RE: DOCKET ID NRC-2009-0435; COMMENTS ON DRAFT ENVIRONMENTAL ASSESSMENT FOR THE RENEWAL OF U.S. NUCLEAR REGULATORY COMMISSION LICENSE NO. SNM-124 FOR NUCLEAR FUEL SERVICES, INC., DOCKET NO. 70-143, OCTOBER 2010

PUBLIC COMMENTS ON DRAFT ENVIRONMENTAL ASSESSMENT (Draft EA) FOR PROPOSED RENEWAL OF NUCLEAR FUEL SERVICES' (NFS) SPECIAL NUCLEAR MATERIALS (SNM) LICENSE FOR 40 YEARS

Sierra Club Nuclear Issues Activist Team

Appendix 9 -- continued
ATTACHMENT 3

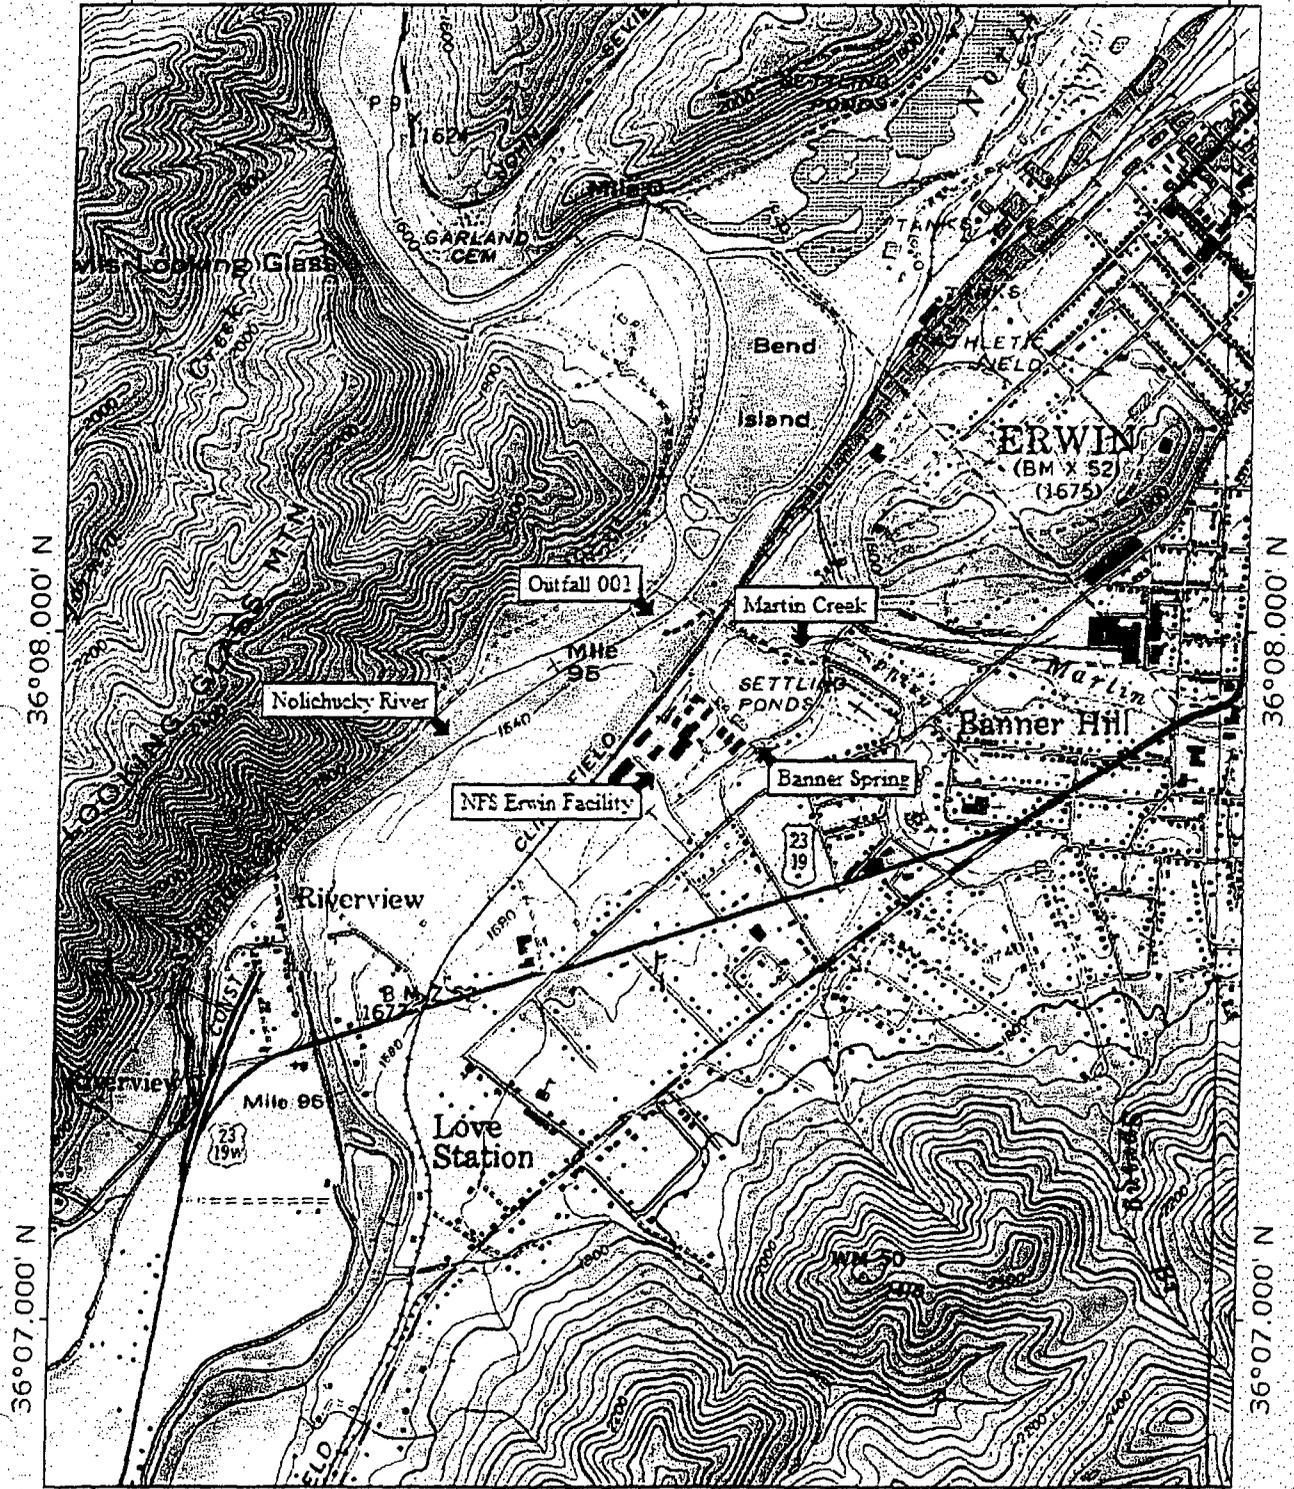
Comment: Appendix 9 includes 2 pages from NFS's NPDES Permit renewal application, 2 pages from Erwin Utilities NPDES Permit renewal application, and a color copy of the latest topographic map of the Erwin Quadrangle. Page A-18, "TOPO! Map printed on 01/27/10 from 'Nuclear Fuel Services.tpo' and 'Untitled.tpg'", clearly marks "Martin Creek", "Banner Spring", "NFS Erwin Facility", "Nolichucky River", and "Outfall 001". On the topographic map on Page A-20, "Erwin WWTP" is clearly labeled and to the northeast of the Erwin WWTP label, in script, are the words "North Indian" following along the creek channel that mostly parallels "New U.S. 23". North Indian Creek shows up even more clearly on the color topo on Page A-21.

Now compare Page A-18 with Page A-21. The former, copyrighted in 2001, does not show "New U.S.

23" cutting across Bend Island and then crossing over North Indian Creek. But it does indicate that, before the four-lane divided highway was built, the Nolichucky wrapped itself around Bend Island and that the river's eastern channel flowed into North Indian Creek (at contour interval 1620). Obvious from the color topo is that highway construction not only restricted the flow of river water to the channel flowing around Bend Island's east, but also created a very narrow channel that was diverted under the highway (at about contour interval 1640) from where it flowed north past the Industrial Park. Martin Creek flows into this Nolichucky River channel just north of where CSX's rail yard starts to widen with a spur for NFS. The Nolichucky channel remains narrow as it flows around Bend Island's east where it ultimately empties – as it historically did – into North Indian Creek (at contour interval 1620). Bottom line: none of the topographic maps, nor Figure 2-1 from the Draft EA, show Martin Creek emptying into North Indian Creek as asserted by the NRC on Page 2-1. The schematic from NFS's now-expired NPDES permit (see Appendix 3, p. A-5) also contradicts Staff's assertion.

Appendix 12 -- continued

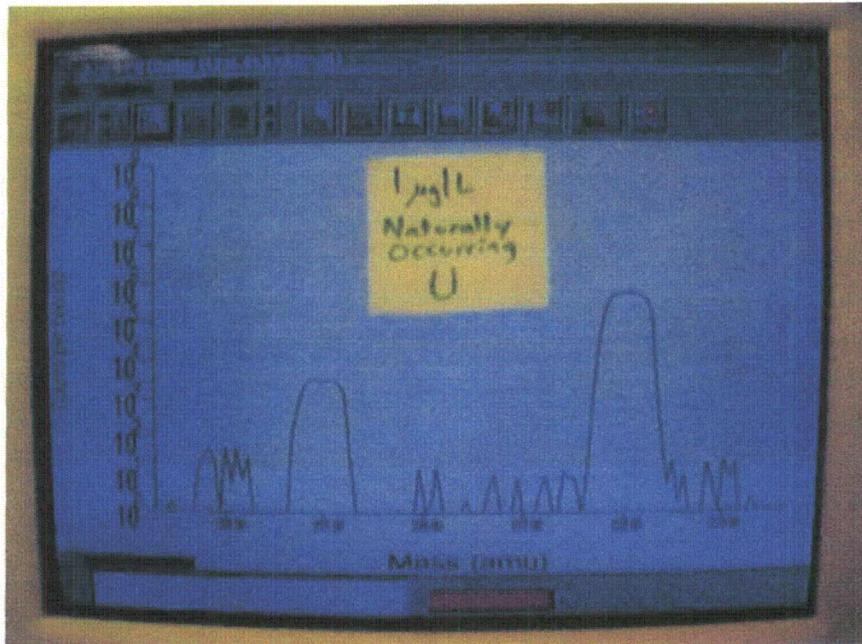
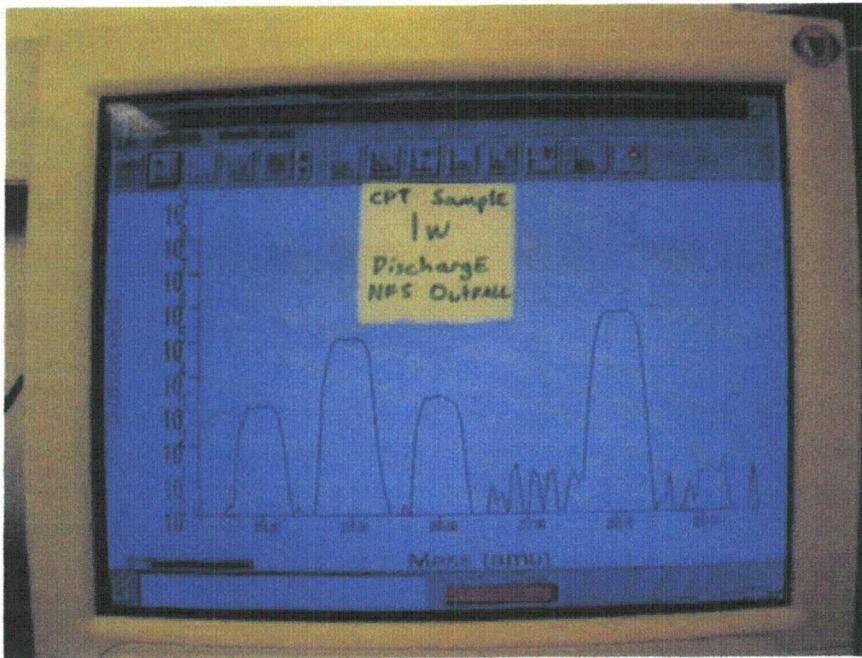
The contrast between U from the NPDES outfall (water sample of May 28, 2010) and naturally occurring U is immediately obvious in the mass spectra depicted below. These plots show (on a logarithmic vertical scale) the relative numbers of atoms of each mass. Note that the naturally occurring U has no detectable ^{236}U , and relative amounts of ^{234}U and ^{235}U vs. ^{238}U are congruent

with the natural signatures. In contrast, the signatures for the NPDES outfall are vastly different and clearly underscore the presence of enriched U.
